Release 0: Original release

HALDEX CONSEP VOLTAGE
Prevost vehicles

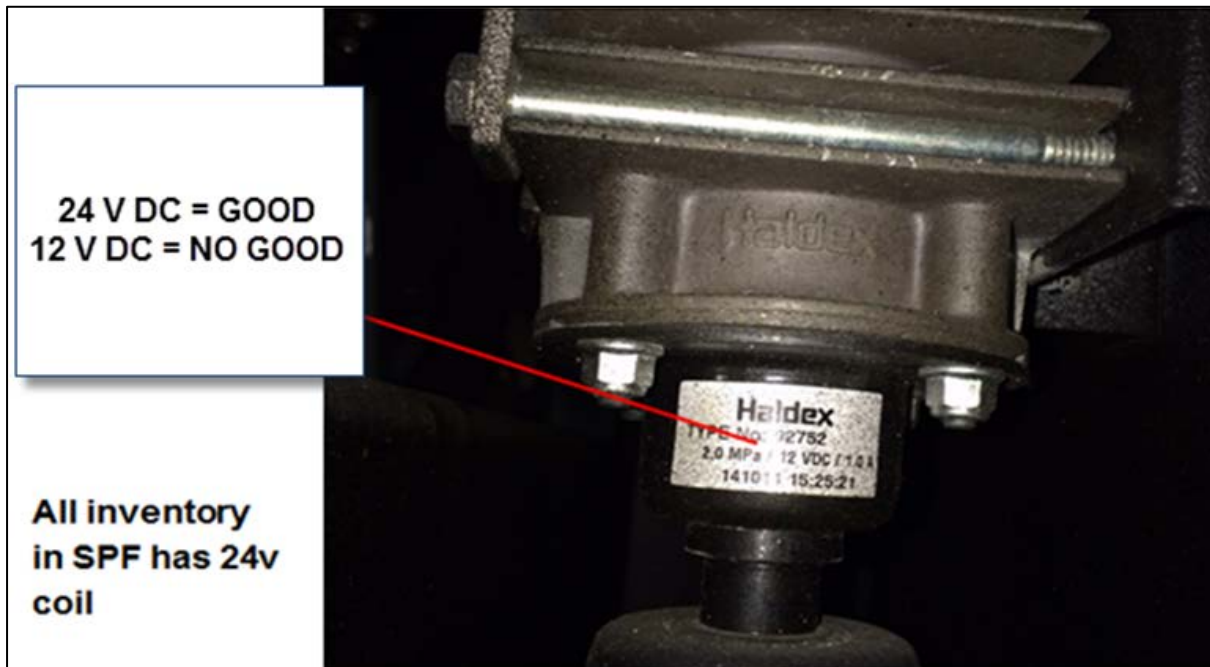
On the vehicles affected by this bulletin, the voltage rating of the condenser / separator coil may be inappropriate for our application. Our application is 24V.

- 1) Inspect the identification plate on the Haldex condenser – separator.
- 2) If the ID plate indicates 12 VDC, replace with a new part #649940. Make sure the new part is rated 24 VDC.
